RE: PZ# 25-12000026 CPTED Waiver for Rising Tide Car wash (2901 W ATLANTIC
BOULEVARD POMPANO BEACH FL 33069, folio 484233450010)

The above-referenced Site Plan application has been reviewed by the Development Review Committee and discussed at the October 15th, 2025 DRC Meeting. Comments are being addressed and resolved with each discipline reviewer, though 3 outstanding comments are related to a necessary zoning code modification/waiver that would otherwise result in a development conflict with the City's CPTED guidelines as well as adjacent property conditions. We would like to take the opportunity to justify the need for Director modification/waiver in accordance with code sections 155.4219.A.1.b [Standards Applicable to Motor Vehicle Sales, Service, and Storage Uses] and 155.5203.F.2.e [Perimeter Buffers; Applicability].

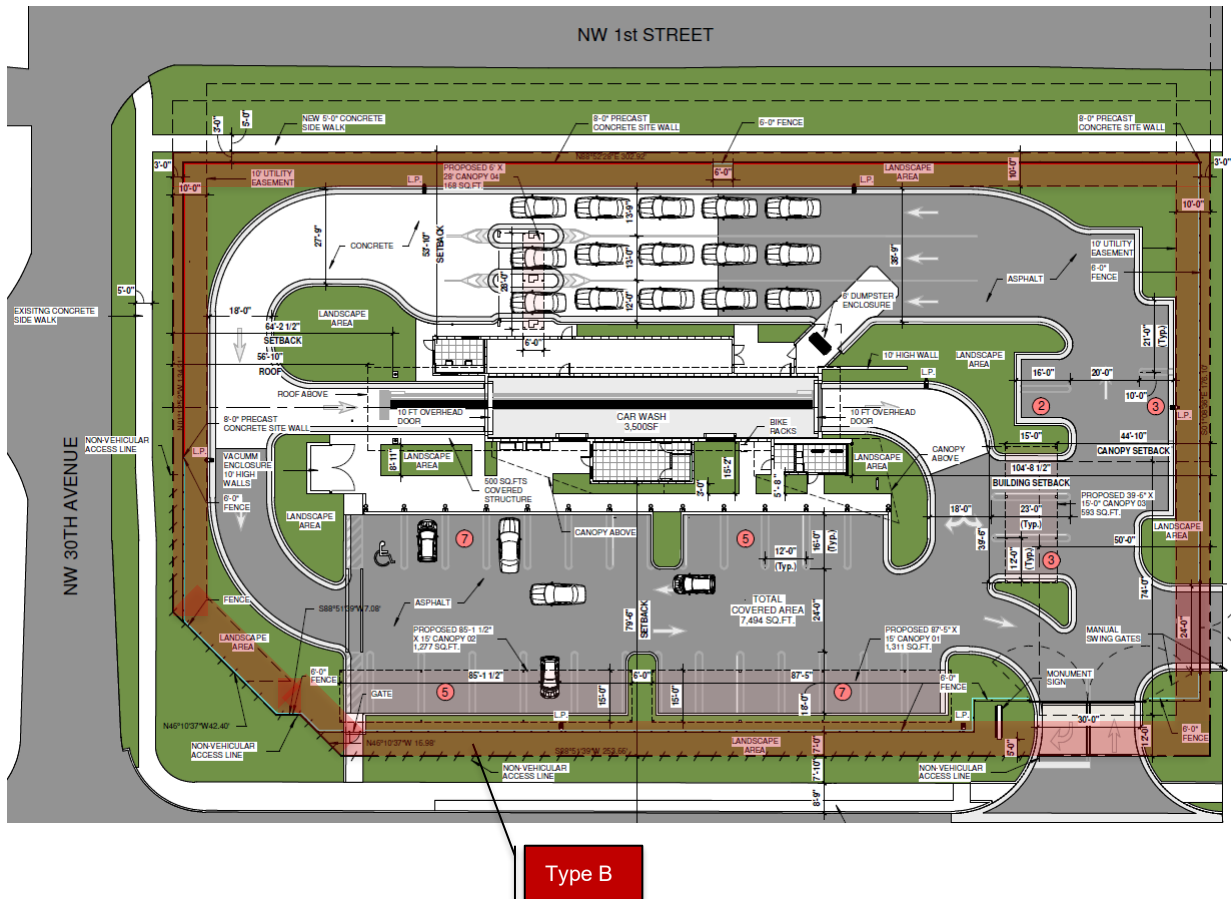
URBAN FORESTRY comment 2 states, "As per 155.4219 note all Type B Buffer along all other perimeters on the plans and provide a cross section detail."

URBAN FORESTRY comment 7 states, "All shrubs associated with the Type B Buffer are required to be 4' tall, please correct."

ZONING comment 11 states, "Please confirm whether the wall along NW 1st Street is located on the property line. The wall is required to be placed in the middle of the landscape buffer, not along the edge. If the wall is currently located directly on the property line, it will need to be relocated to comply with this requirement."

As shown below, the property is surrounded by 3 streets to the north, west, and south. Across the north side is a residential neighborhood that would benefit from a privacy wall along that perimeter. As a Type B Buffer is required per code section 155.4219.A.1.b for all perimeters, we request all continuous hedging required within the Type B Buffer be eliminated where the proposed CPTED fence is shown. For a portion of the west, all of the south, and all of the east perimeters, we propose the buffer barrier to be a CPTED-style high-visibility fence, in accordance with conversations had with BSO Deputy Anthony Russo.

The east perimeter abuts a vacant property; however, the recorded plat for the subject property includes a cross-access easement for the benefit of the property to the east. We propose an arm gate for 1. the future access of that development, and 2. to eliminate any potential queuing on to Atlantic Boulevard.

Requiring the buffer barriers to be completely solid from street views (including continuous hedging) not only violates the city's CPTED guidelines for Natural Surveillance but also provides incompatibility between commercial and residential properties. Below is a summary of the buffer modifications/waivers we are requesting, with a diagram for these:
